APPLICATION NO.	FILING DATE	FIRST NAMED INVENTOR	ATTORNEY DOCKET NO.	CONFIRMATION NO.
10/627,893	07/25/2003	Eric C. Hannah	42P12034D2	3477

Office Action Summary

DETAILED ACTION

REPLACEMENT SHEET

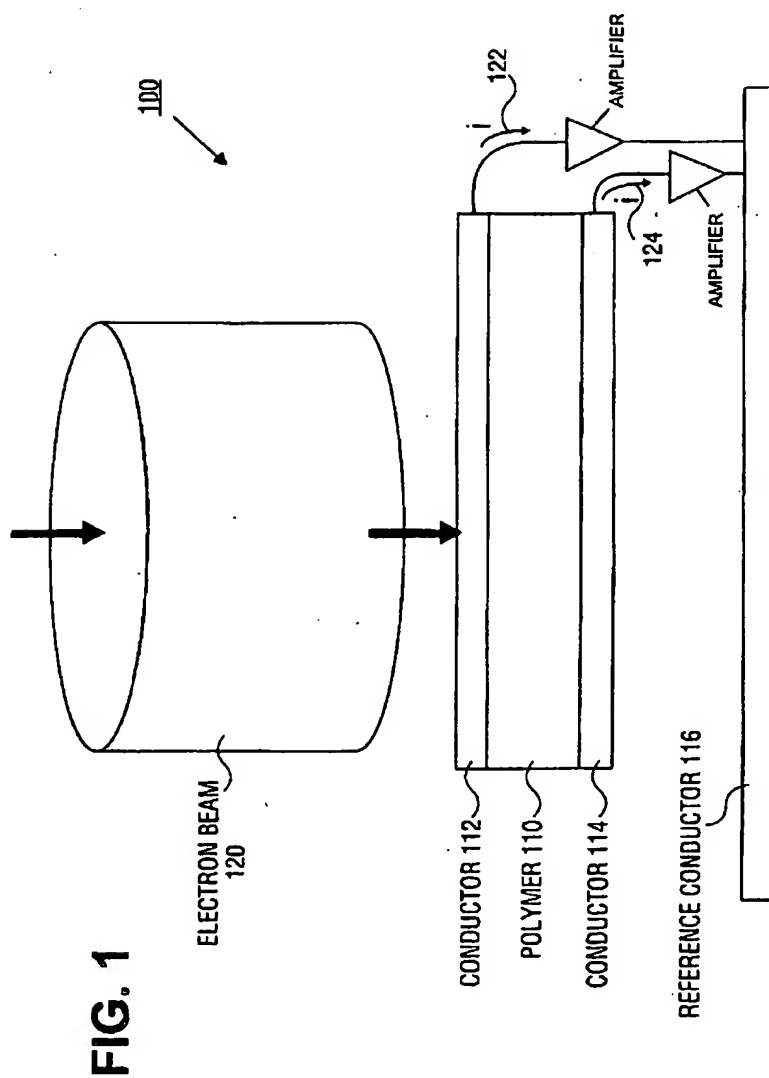
1. The replacement sheets of drawings were received on 9/21/06. These drawings are acceptable for the purpose of examination.
2. The drawings are objected to as failing to comply with 37 CFR 1.84(p)(5) because they include the following reference character(s) not mentioned in the description: ***amplifier in Fig. 1; interlayer in Fig. 2***. Corrected drawing sheets in compliance with 37 CFR 1.121(d), or amendment to the specification to add the reference character(s) in the description in compliance with 37 CFR 1.121(b) are required in reply to the Office action to avoid abandonment of the application. Any amended replacement drawing sheet should include all of the figures appearing on the immediate prior version of the sheet, even if only one figure is being amended. Each drawing sheet submitted after the filing date of an application must be labeled in the top margin as either "Replacement Sheet" or "New Sheet" pursuant to 37 CFR 1.121(d). If the changes are not accepted by the examiner, the applicant will be notified and informed of any required corrective action in the next Office action. The objection to the drawings will not be held in abeyance.

3. The drawings are objected to under 37 CFR 1.83(a). The drawings must show every feature of the invention specified in the claims. Therefore, ***the transparent layer as recited in claims 28 and 44*** must be shown or the feature(s) canceled from the claim(s). No new matter should be entered.

Regarding Fig. 1 of the present invention, it is not clearly understood and how either one of the currents may be used to associate the state of the conductivity within the polymer 110 with the memory state of data stored in a bit when the polymer 110 is highly resistive, as described in paragraph [0016] because, as seen in Fig. 1 of the present invention, when the polymer 110 is highly conductive, the current 122 and the current 124 are both pouring down to the reference conductor 116; similarly, it is not

clearly understood how once the current has been steered, according to the state of the polymer 110, many embodiments of the present invention may be used to read the current, as described in paragraph [0017] because, first of all, the specification does not clearly describe which of the current 122 or 124 has been steered according to the state of the polymer 110, secondly, Figs. 2-4 of the present invention do not show any embodiment associated with the reference conductor 116 as shown in Fig. 1 of the present invention, and, thirdly, as a result, it is not clearly understood what the reference conductor 116, as shown in Fig. 1 of the present invention, is really used for.

b) Regarding the objection to the drawings under Rule 37 CFR 1.83(a), the amended Fig.1 now show the amplifier as recited in claims 19-20. However, the specification fails to describe the amplifier and the substantially transparent layer as recited in claims 28 and 44 is still not shown in the drawings of the present invention.
